CM-25 MINE PERMIT AMENDMENT
APPLICATION PERMIT No. M-1977-307
Response to Adequacy Review #2

January 2013

CM-25 Mine, File No. M-1977-307, Amendment (AM1) Application Adequacy Review (2)

SECTION F-F

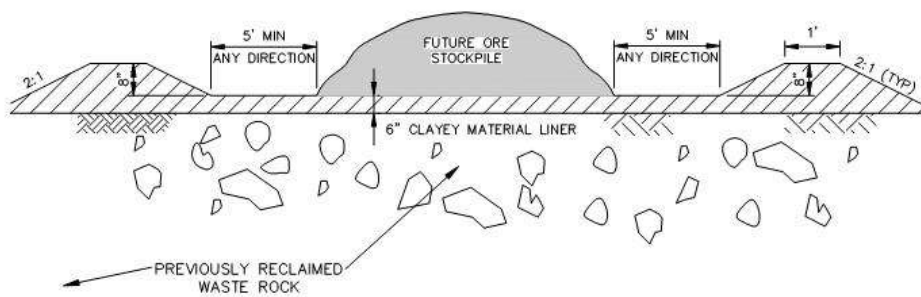
7. *Sheet 4. Please provide some material and compaction specifications for the berm and the retention pond embankment.*

8. *Sheet 5. Please provide spillway location, designs (sections and profile), and specifications sufficient to convey the design flow to the toe of the embankment.*

Material and compaction specifications are provided in Attachment 2 for the proposed containment berm and pond embankment.

New spillway design details and broad-crested weir calculations are included in Attachment 3.

COTTER CORPORATION
MINE SITE CM-25

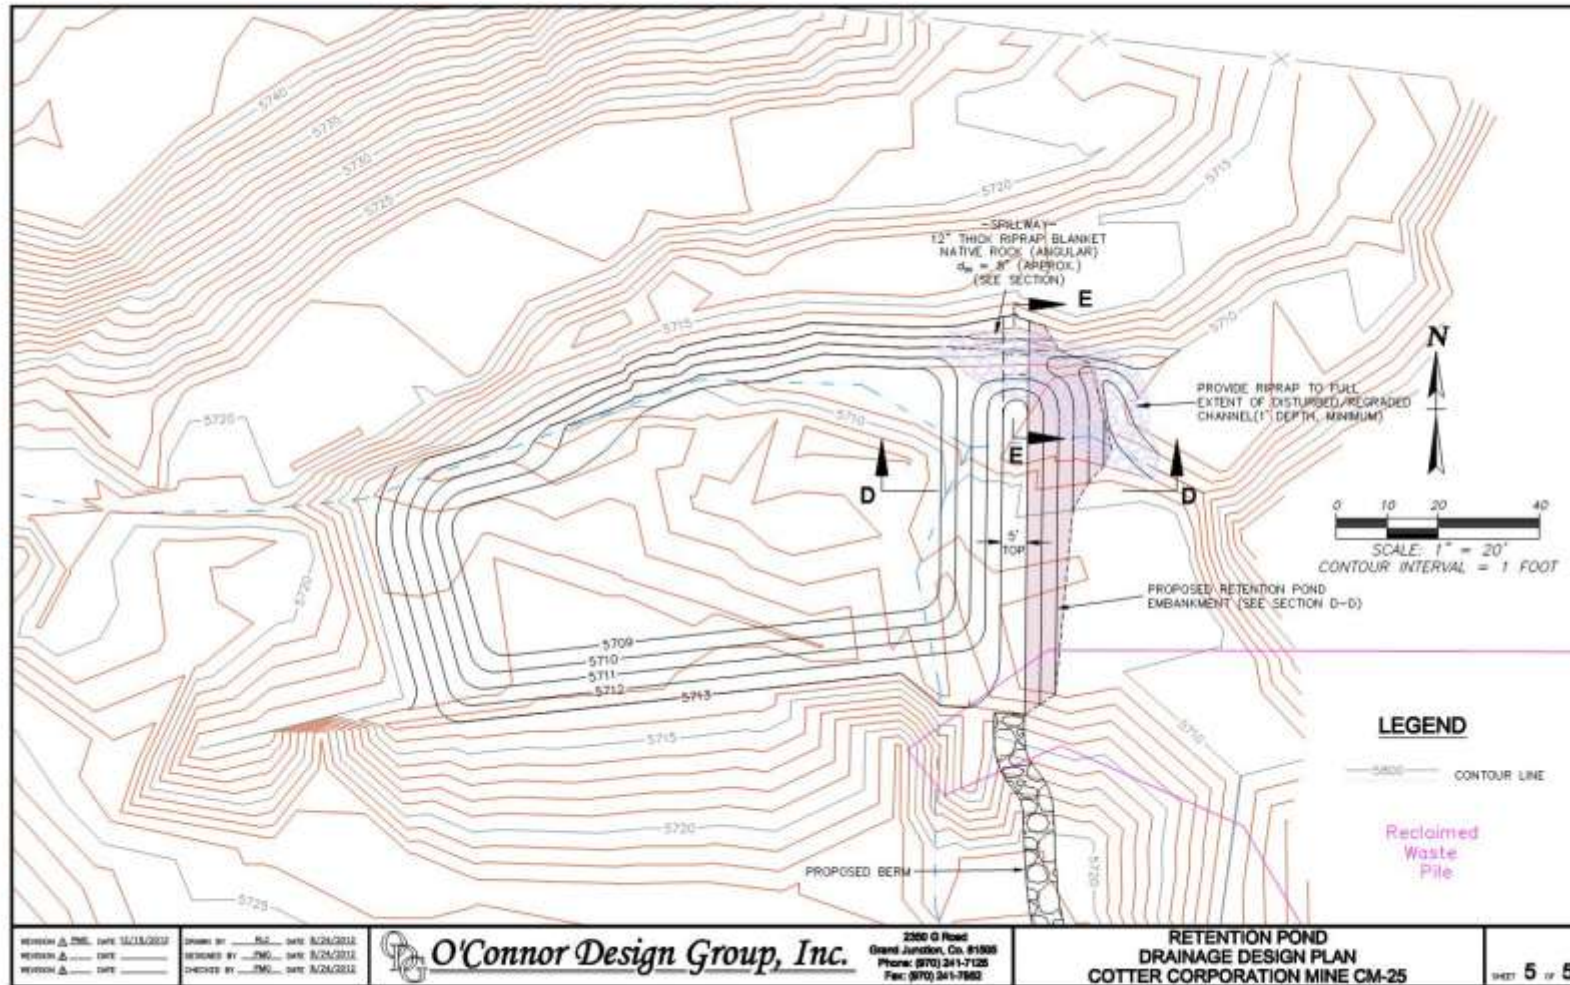
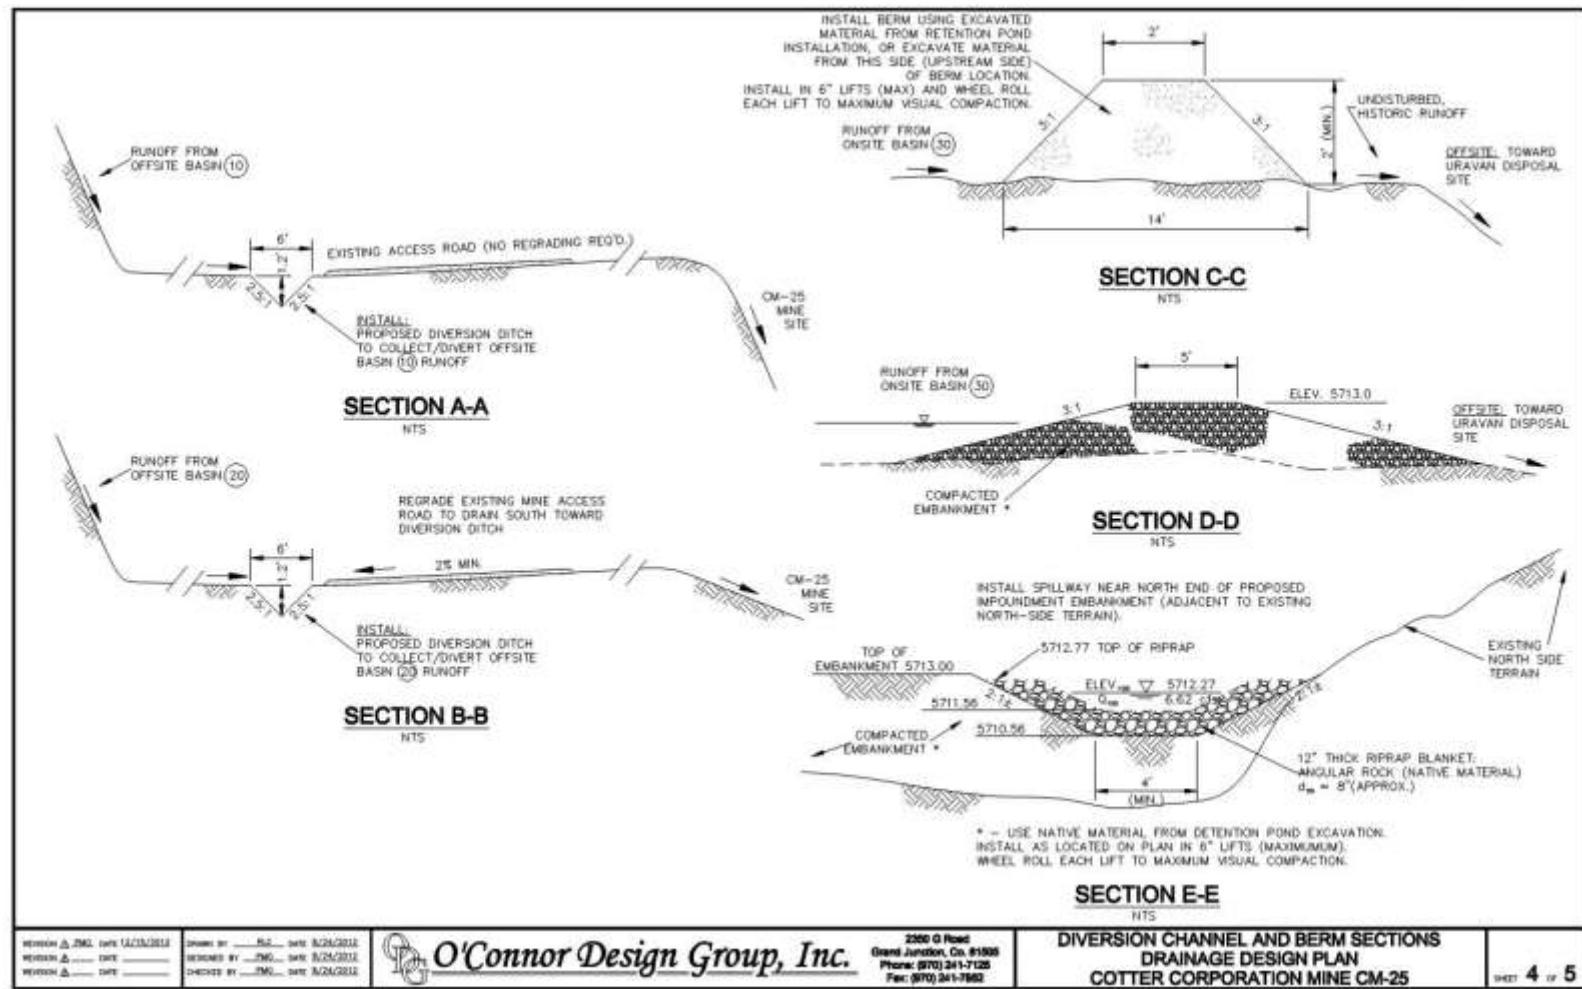
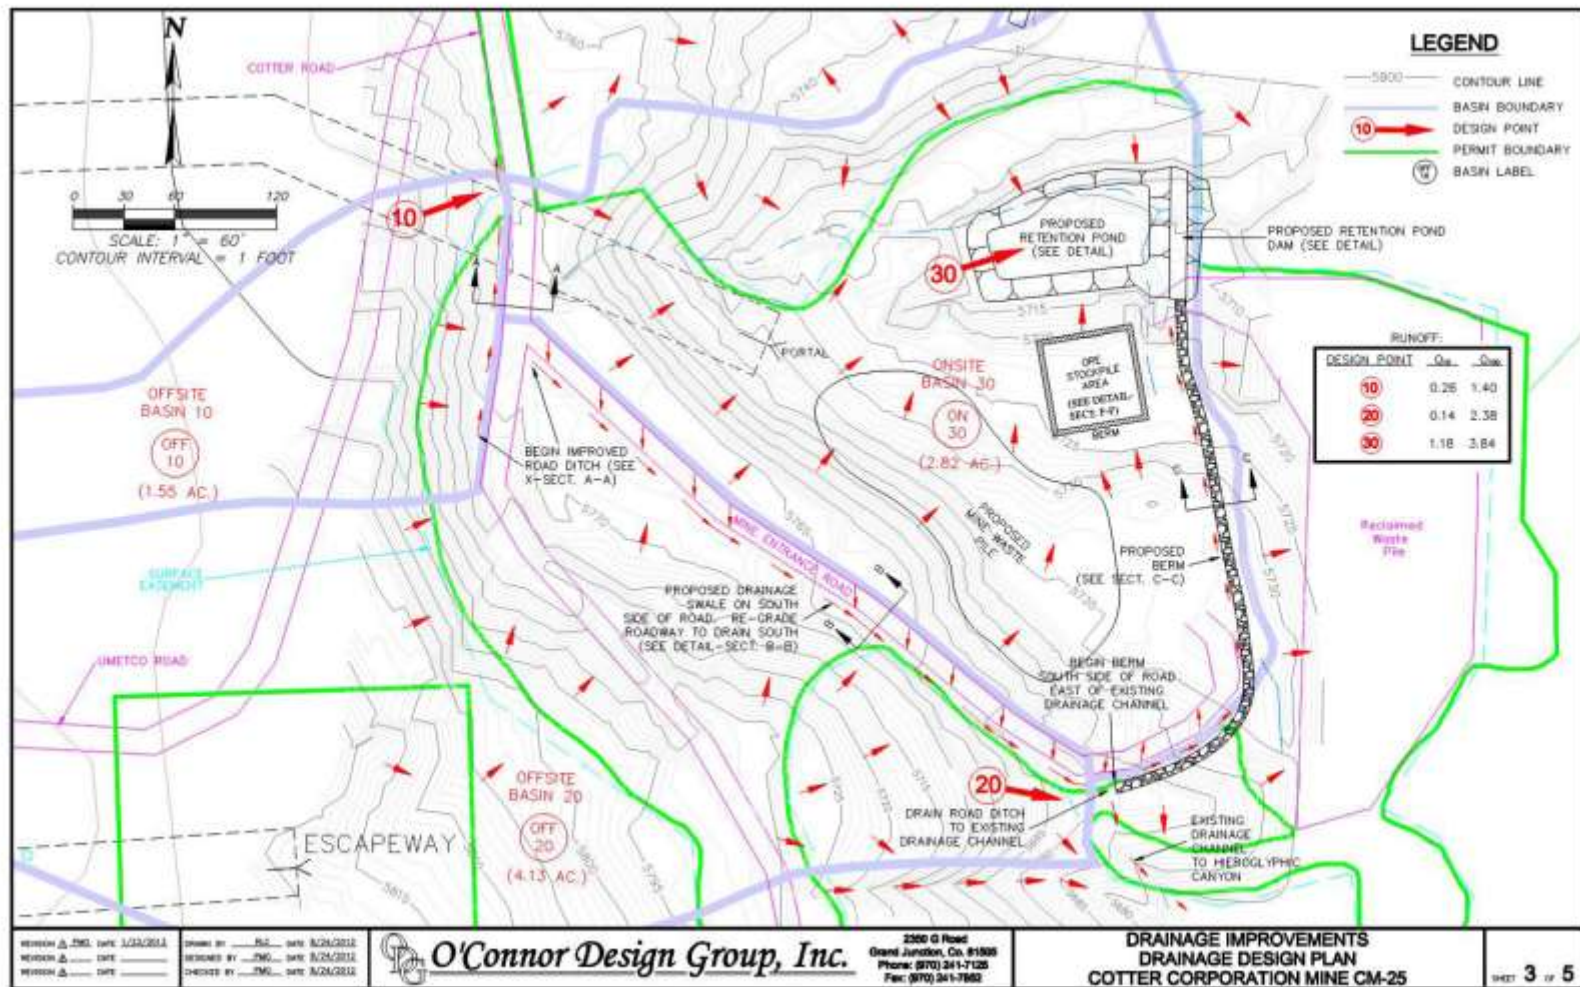
1. *Page ESWMP-2, third paragraph and Sheets 2 and 3 – Waste rock stockpile. The waste rock stockpile discussed in these two paragraphs is not labeled on either Sheet 2 or 3, unless the Applicant is referring to the “Reclaimed Waste Pile”. Please clarify where the waste rock stockpile and other facilities mentioned in the second paragraph are to be located and identify this area on Sheet 2 and 3.*
 - a. *The third paragraph states clay will be placed on the waste rock stockpile. Please clarify as to whether this clay is intended to be a liner, cap or both; and provide some engineering details (e.g., thickness, compaction, permeability, etc.)*

4. *Page ESWMP-6, second paragraph and Retention Pond Drainage Design Plan (Sheet 5 of 5). The 100-year, 24-year runoff volume criteria used for sizing storage in the pond is acceptable. However, a spillway is necessary to pass runoff from successive storms as there is no way presented in the Retention Pond design plan to drain the pond via gravity. As such, the emergency spillway for the pond needs to be designed to convey 100-year peak flow, assuming the ponds are full (to the spillway invert elevation) at the onset of the design storm. Please provide analyses and designs to demonstrate the spillway has the capacity to pass the peak flow resulting from the 100-year, 24-hour design storm. (Note – The DRMS checked with the Colorado Division of Water Resources District 60 water commissioner (Aaron Todd) regarding the status of the San Miguel River appropriations. Mr. Todd stated that the San Miguel River is not currently over appropriated and as such, DWR has no current requirement to release retained stormwater within 72 hours. He also indicated this is subject to change.)*

The waste rock stockpile discussed in the report refers to future waste rock to be placed on the site once mining production resumes and will be located within the topographic “bowl” existing around the old portal area, bounded by the mine access roadways, the natural hillside to the north, and the proposed berm and retention pond to the east. The proposed locations of the waste rock stockpile, ore stockpile area, and retention pond are shown on the attached revised Sheets 2 and 3 in Attachment 4.

We have revised the retention pond details to incorporate a spillway capable of passing the 100-year runoff. The bottom of the spillway has been set at the elevation of the 10-year storm storage, with rock armoring the channel bottoms and sides (rock is on top of the channel bottom, above the 10-year elevation). Analysis for a broad-crested weir of the dimensions specified was used to verify the capacity. The weir is capable of passing more than the projected 100-year event with the pond providing retention of the 10-year volume. Analysis was completed using the 24-hour rainfalls provided by the NOAA Atlas for the area.
